U. S. NUCLEAR REGULATORY COMMISSION

Reports No. 50-315/83-09(DRMSP); 50-316/83-10(DRMSP)

Facility Name: D. C. Cook Nuclear Power Plant, Units 1 and 2

1. Emergency Preparedness
Safety Evaluation Report
Related to the Operation of
the Donald C. Cook Nuclear Plant,
Units 1 and 2
2. Flow Chart for General Emergency
Offsite Protective Decisions

FIGURE 1

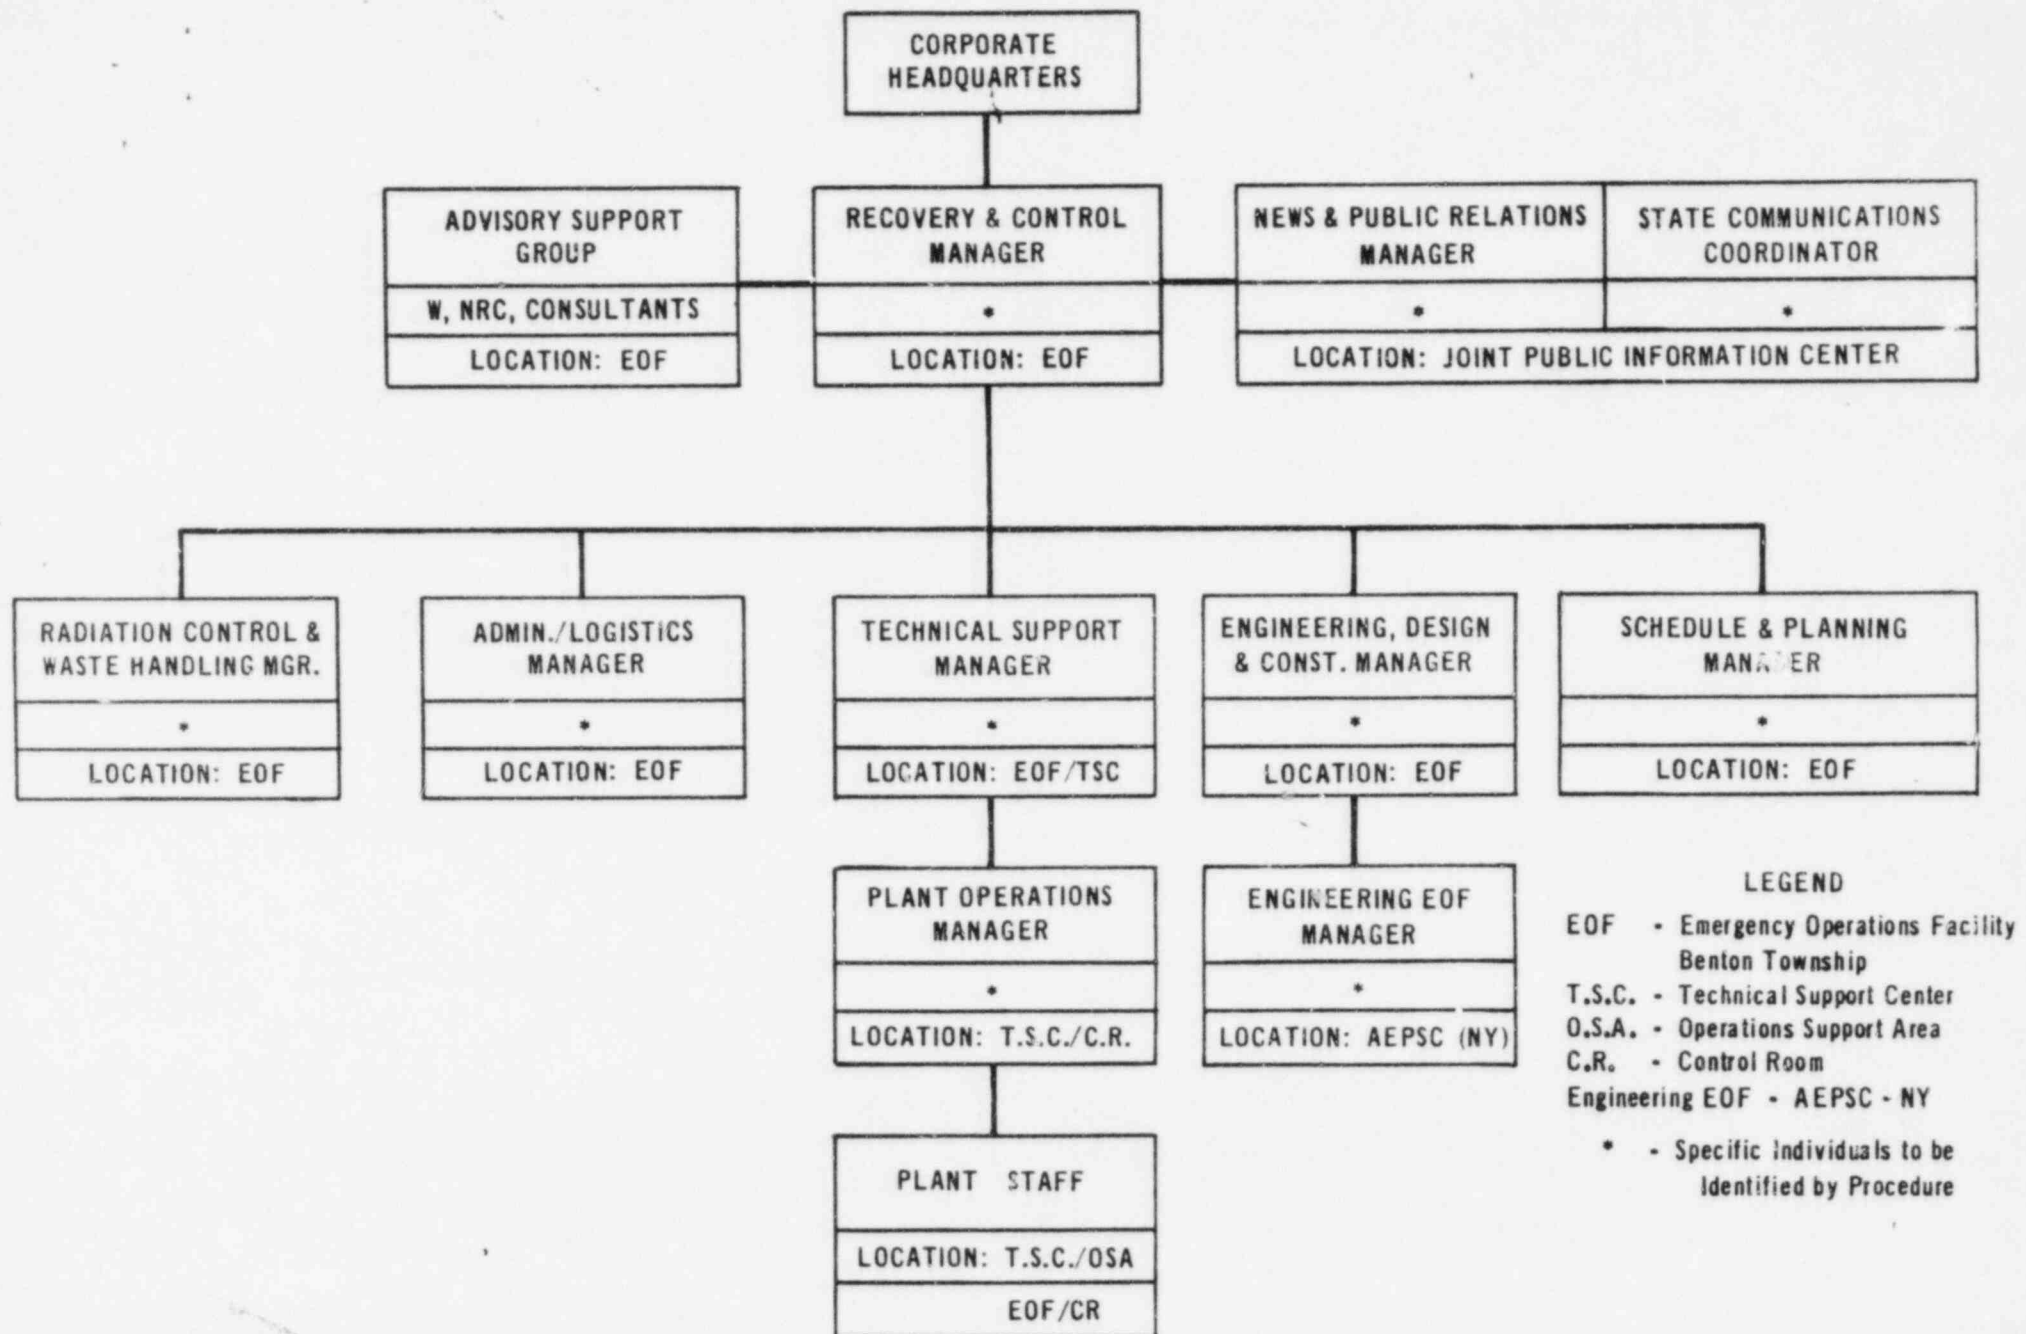
The total emergency response organization is shown in Figure 1, which identifies the various primary emergency response personnel. Principal interfaces and primary responsibilities for each of these individuals are specified in the plan. Emergency functions addressed in the organization are as follows: command and control, logistics support, engineering support, technical support, manpower requirements, scheduling and planning, public information, design and construction support, waste systems radiation control support, administrative support, and advisory support.

This element of emergency preparedness as described in the Donald C. Cook Nuclear Plant Emergency Plan is acceptable; however, resolution of the City of Bridgeman letter of agreement should be made in the next plan revision.

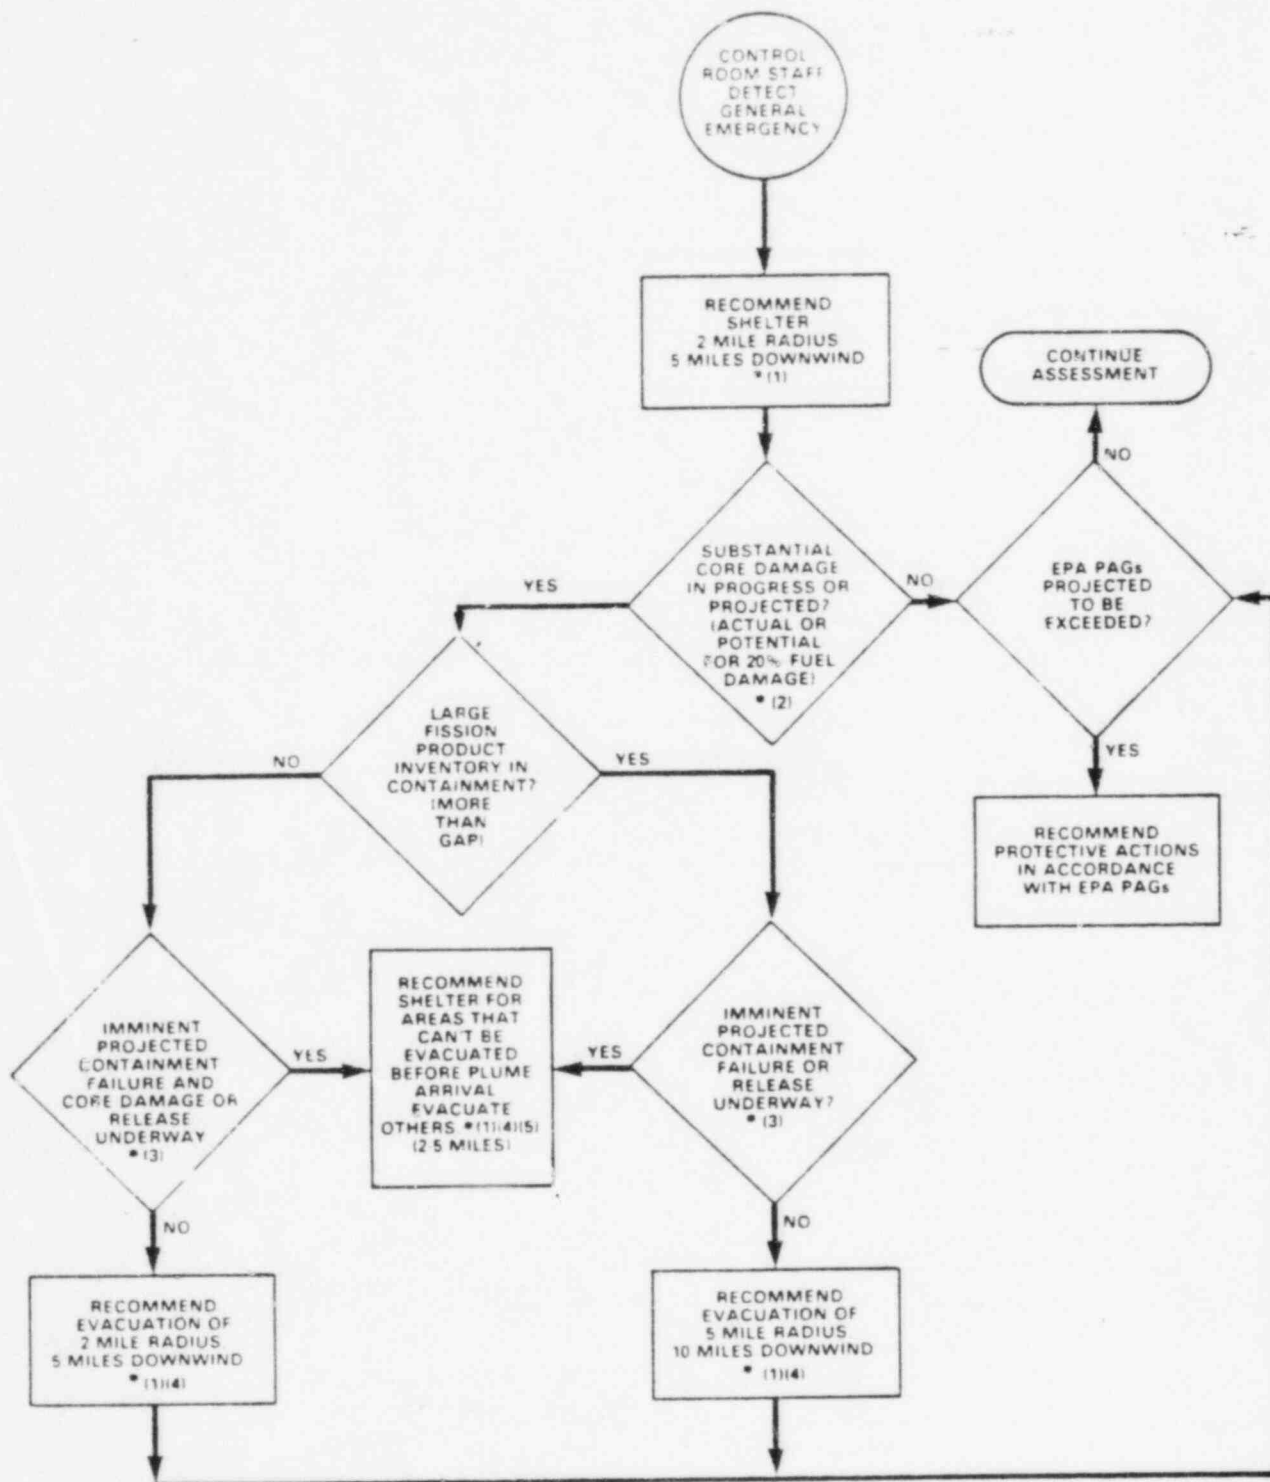
Based on our review of the Indiana and Michigan Electric Company Donald C. Cook Nuclear Plant Emergency Plan and supplemental correspondence, we conclude that upon satisfactory clarification of the items listed below, the licensee's emergency plan will meet the planning standards of 10 CFR 50.47(b) and the requirements of 10 CFR Part 50, Appendix E. The required clarifications are summarized as follows:

1. Clarify Section 12.3.6.1.3 of the plan to clearly indicate that offsite notifications occur for any emergency declaration rather than just those that may affect offsite individuals. (Planning Standard E)

2. Clarify Section 12.3.6.2 as to when off-shift augmentation will occur, e.g., although TSC and OSA are activated for any Alert or higher emergency classification, the plan does not clearly indicate that shift augmentation will occur to staff these centers. (Planning Standard E)
